Quick investigation of BA15 cap-holder systems

Evaluation proposal Valeo (reference TF SR-01-10)

Examination Valeo Proposal:

Check: BA15d-3-LED Holder-^{v/s} non-LED caps

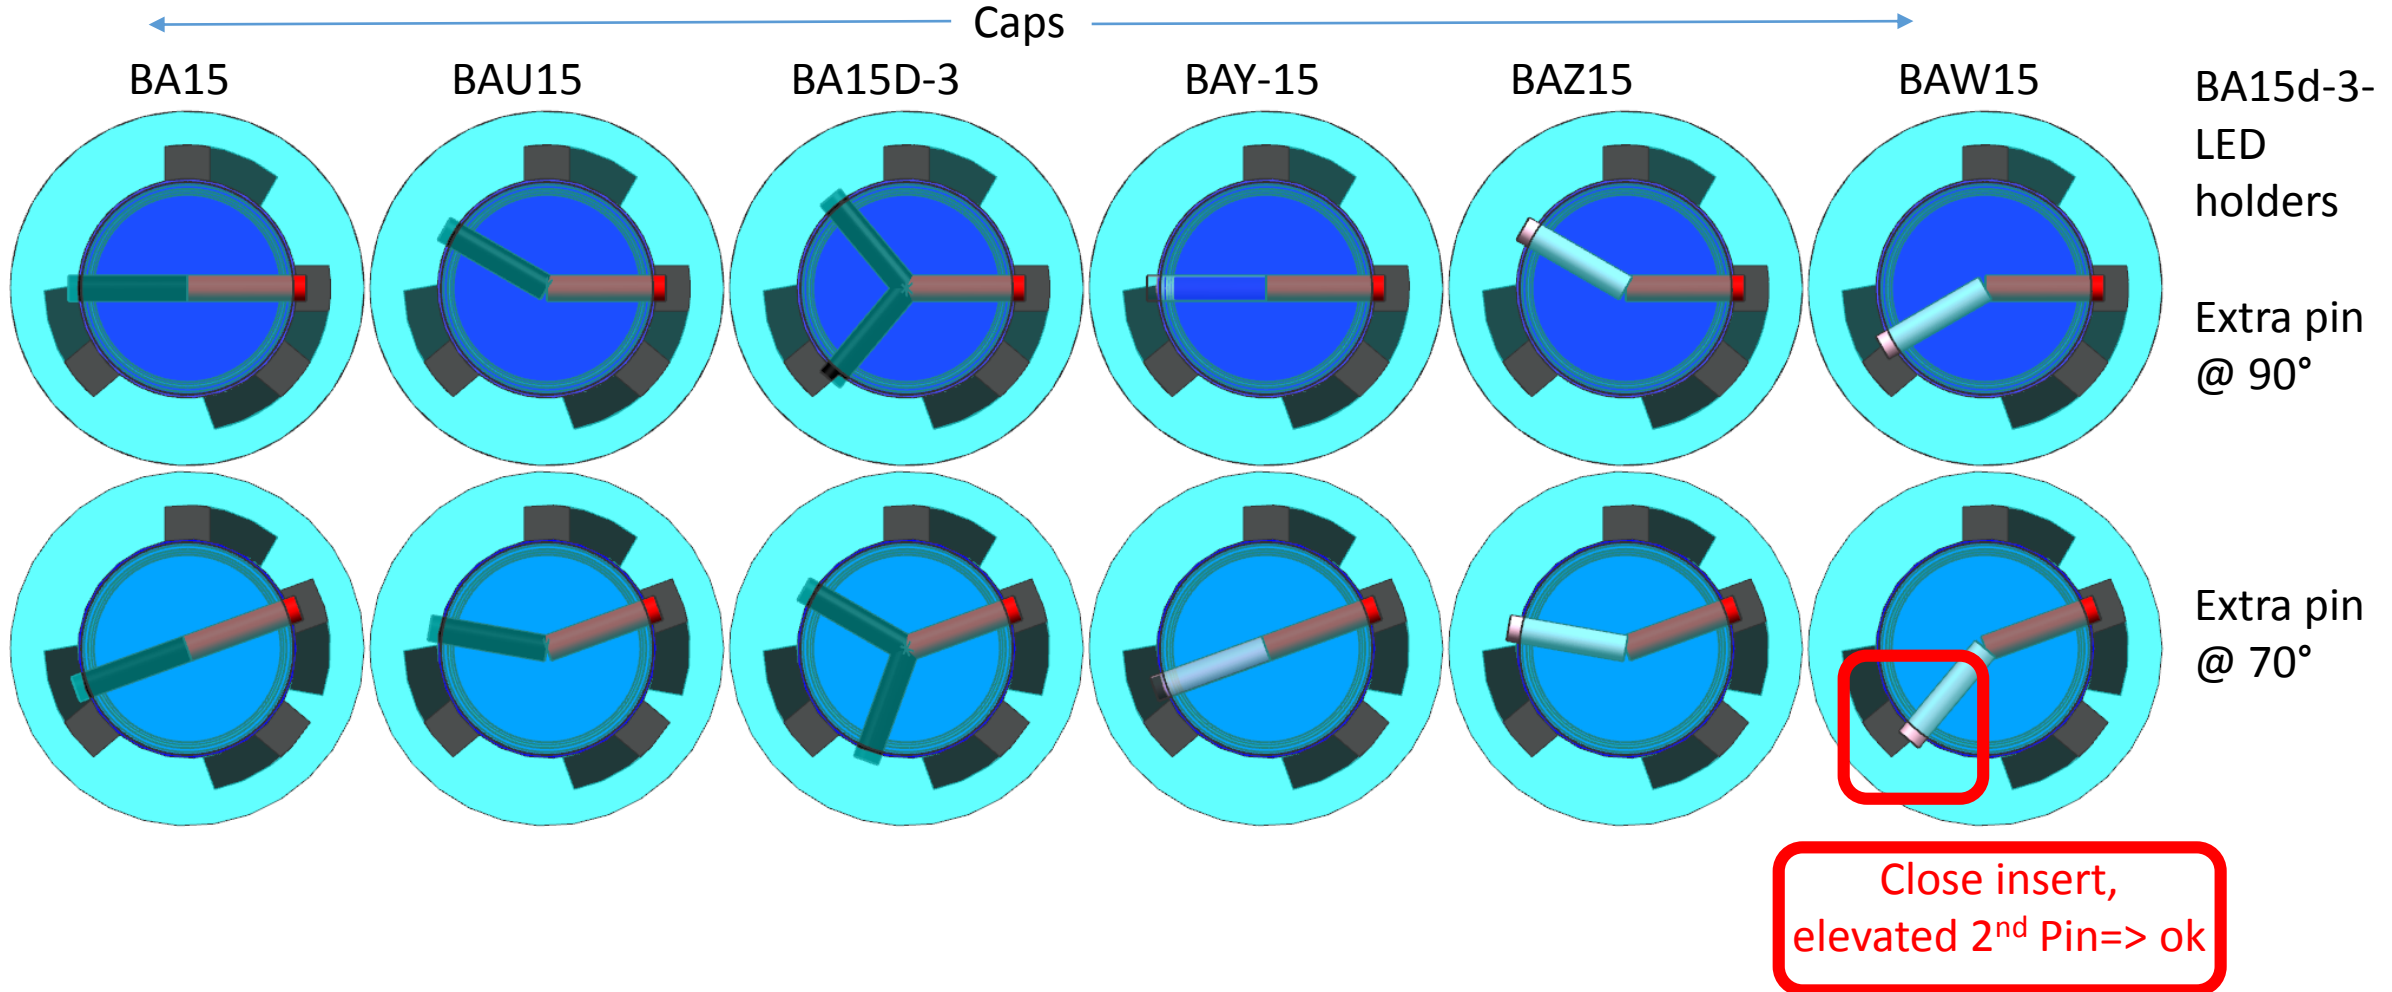
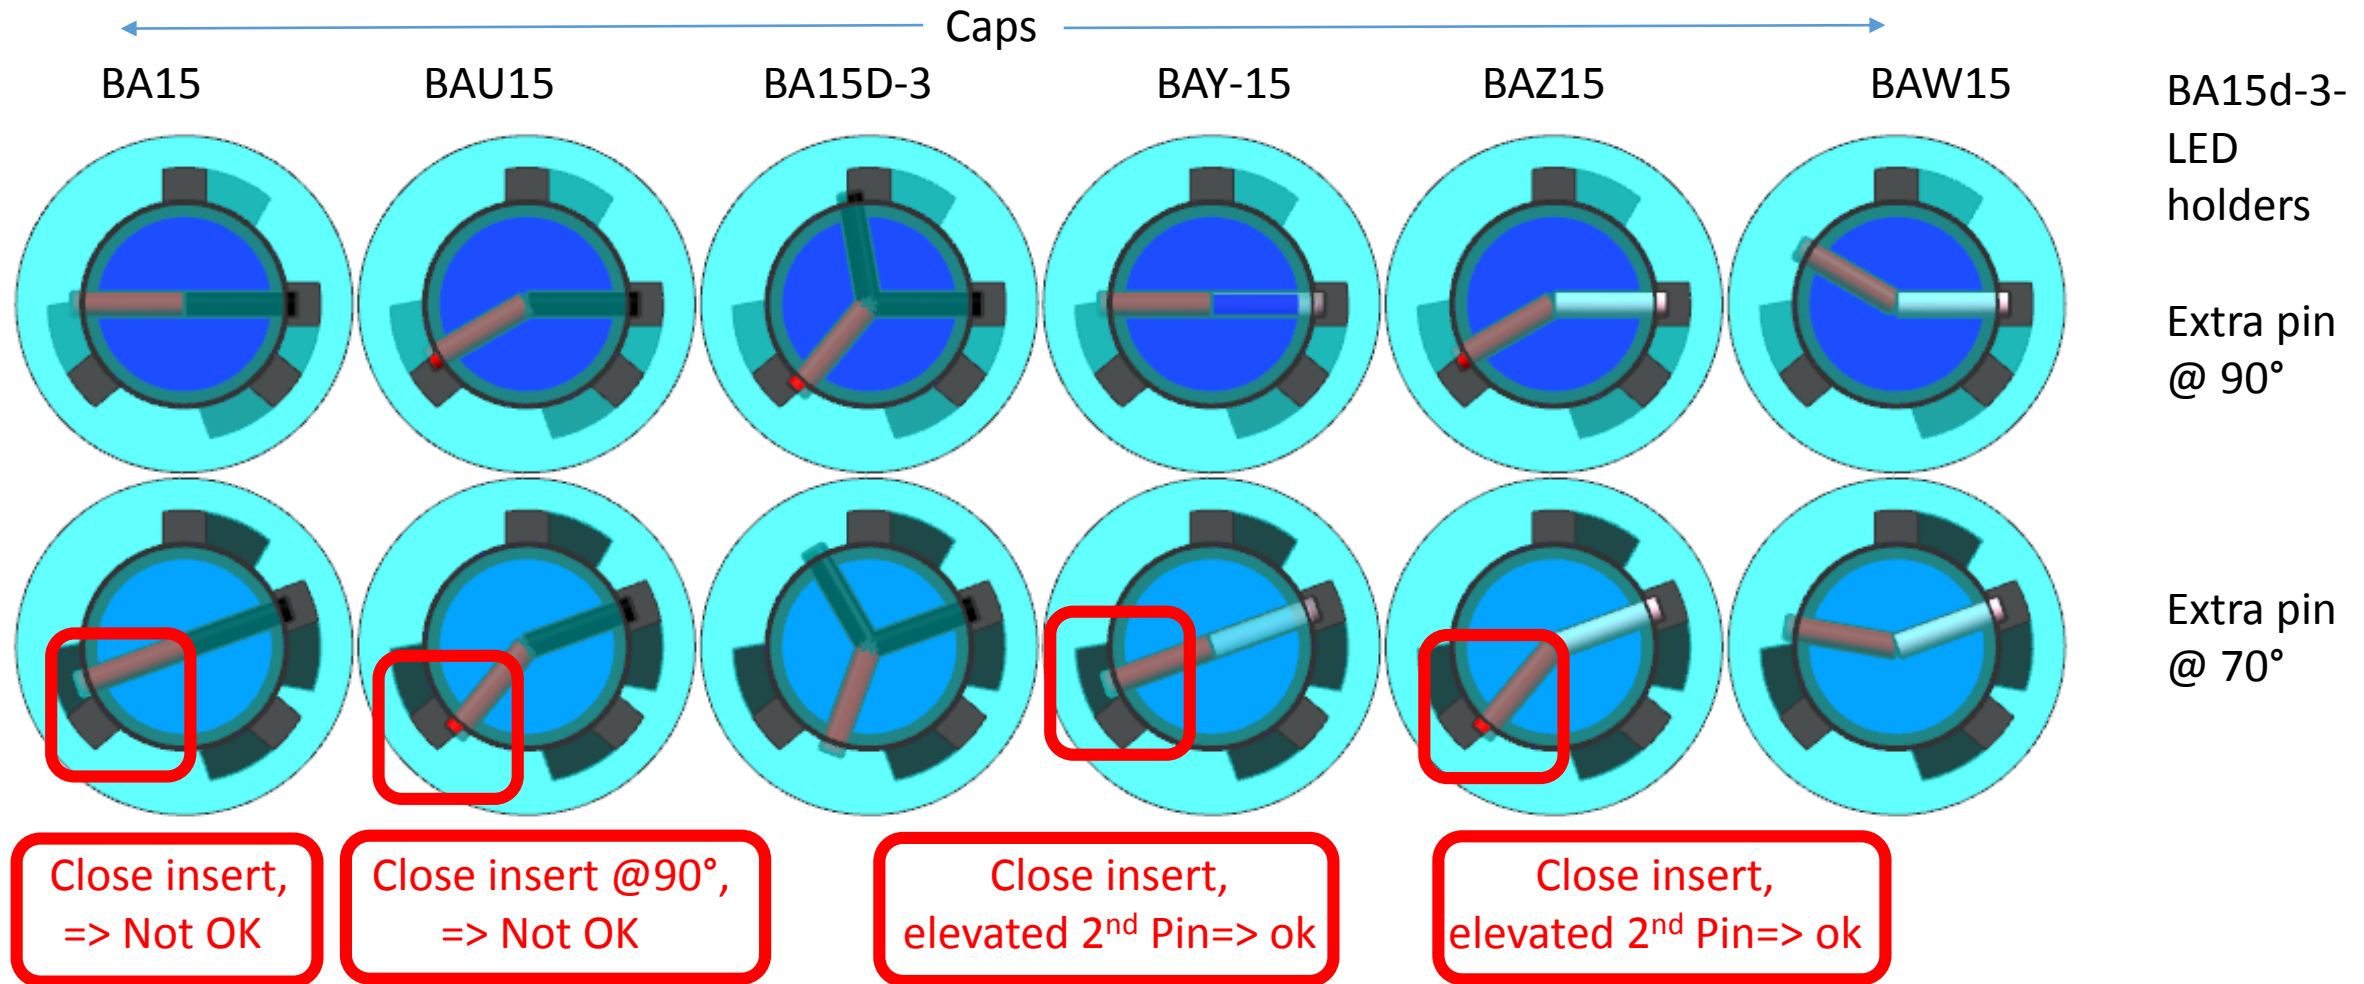
Ref pin in new slot

Check: BA15d-3-LED Holder- \forall_s non-LED caps Non-Ref pin in new slot

Check: BAY15-LED Holder-^v/_s non-LED caps

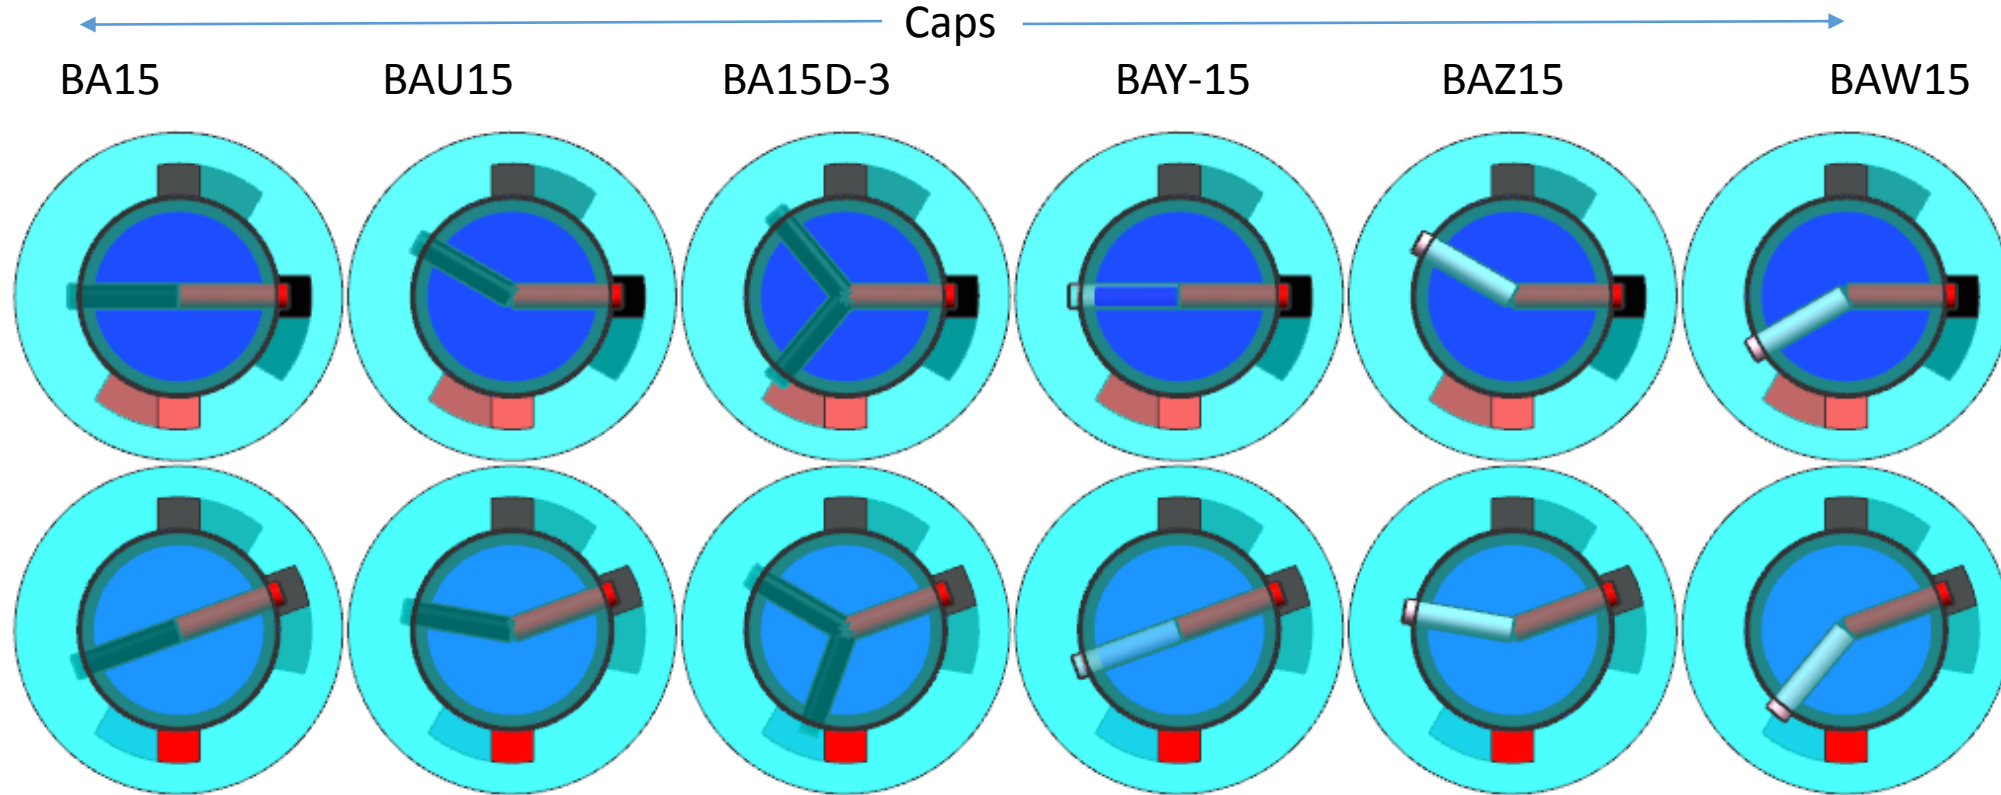
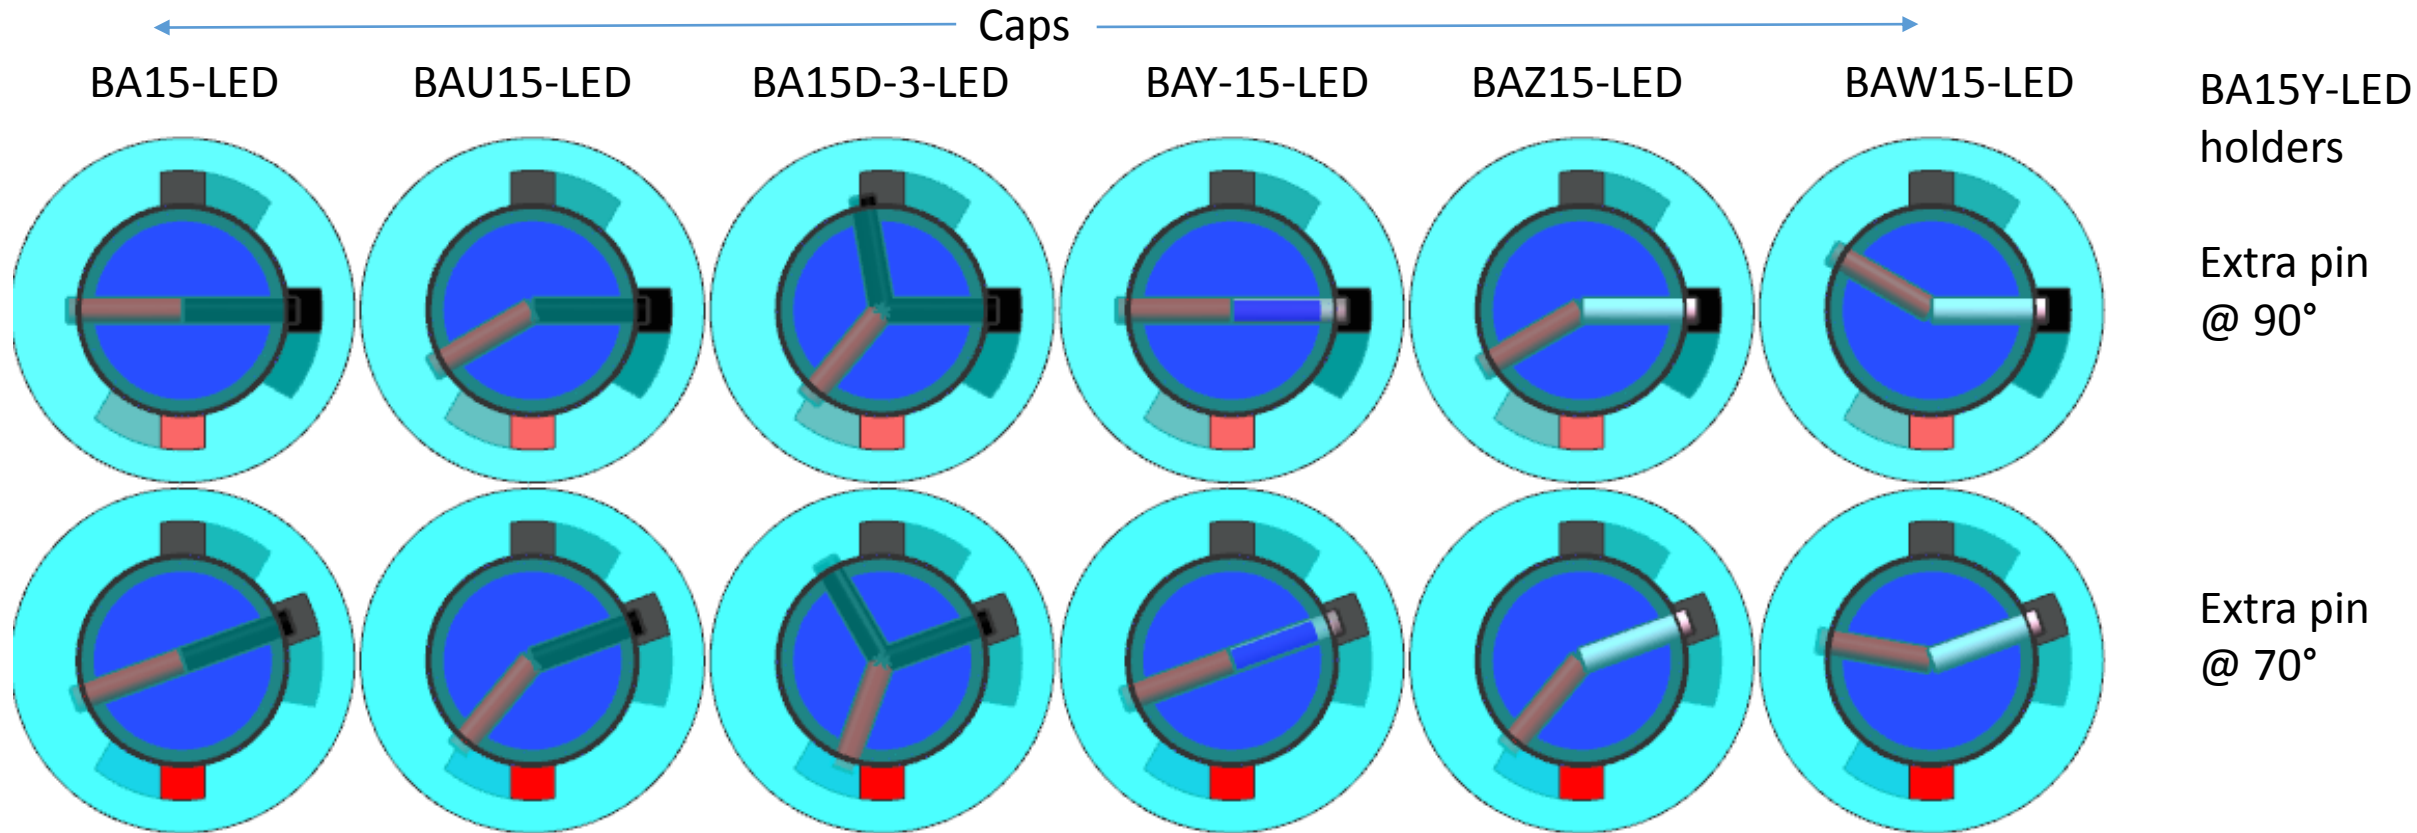
Ref pin in new slot

Non-Ref pin in new slot
